GNRO-2011/00070

SUBJECT: Request for Additional Information Regarding
Extended Power Uprate
Grand Gulf Nuclear Station, Unit 1
Docket No. 50-416
License No. NPF-29

Response to Request for Additional Information

Mechanical and Civil Engineering Branch

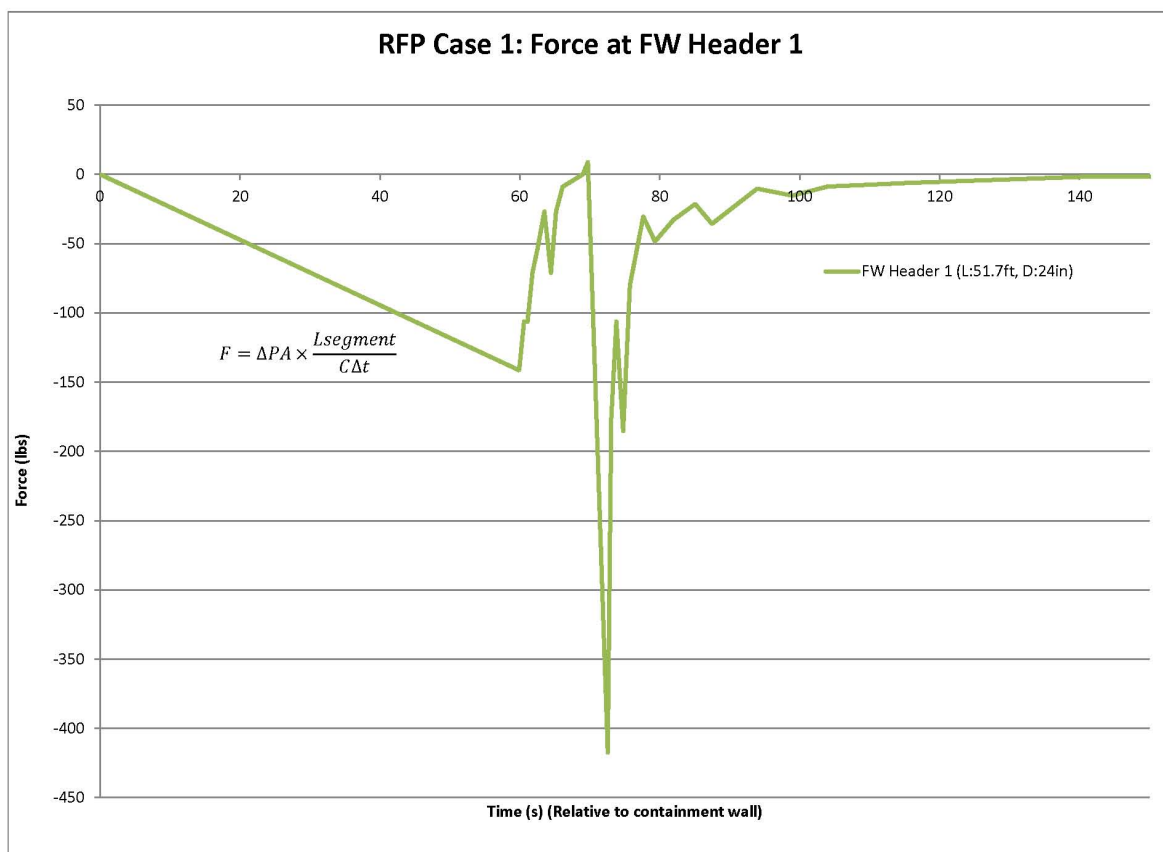
In its June 15, 2011, response to RAI 2 b), Entergy Operations, Inc. (Entergy or the licensee) stated that the 13.1 percent feedwater (FW) flow rate increase accompanying the proposed extended power uprate (EPU) implementation at Grand Gulf Nuclear Station (GGNS) does not affect the stresses in the FW piping system. The licensee stated that the design basis of the FW piping system does not include loads which are governed by flow rate, including water hammer and transient loads. As such, the FW pipe stress analysis of record (AOR) does not credit pipe stresses resulting from flow-induced transients. While the design basis of the FW piping system does not include stresses resulting from water hammer and other flow-induced transients, the NRC staff requests that the licensee provide a technical justification which demonstrates that the FW piping and supports will maintain their structural integrity following transients whose load consequences would be amplified by the proposed flow increase accompanying EPU implementation at GGNS. Transients which should be considered include, but are not limited to, a FW pump trip, FW regulating valve closure and FW isolation valve closure. This technical justification should quantitatively demonstrate that the American Society of Mechanical Engineers Boiler and Pressure Vessel (ASME B&PV) Code allowable values used in the original design of the FW piping system will continue to be satisfied following these events, upon implementation of the proposed EPU at GGNS.

For the FW piping (including the safety related portion), the most limiting transient loading due to the pressure wave acting on the piping system was a maximum of 420 lbf (see the attached Figure "RFP Case 1: Force at FW Header 1"). The peak force resulted in a "g" loading on the piping system of 0.016964 g. The FW piping design included loads from thermal, dead weight, seismic and annulus pressurization anchor movements, safe shutdown earthquake (SSE), and SRV actuations. The transient hydraulic loads considered in the piping design from SRV actuations applied a "g" loading of approximately 2 g's. When the load from the limiting system operation hydraulic transient (trip of two FW pumps) is combined with the SRV load using the standard SRSS (square root of the sum of squares) method, the resulting load would increase from 2.0 g's to 2.000072 g's. The increase in the total piping design load from the limiting hydraulic transient is thus negligible.
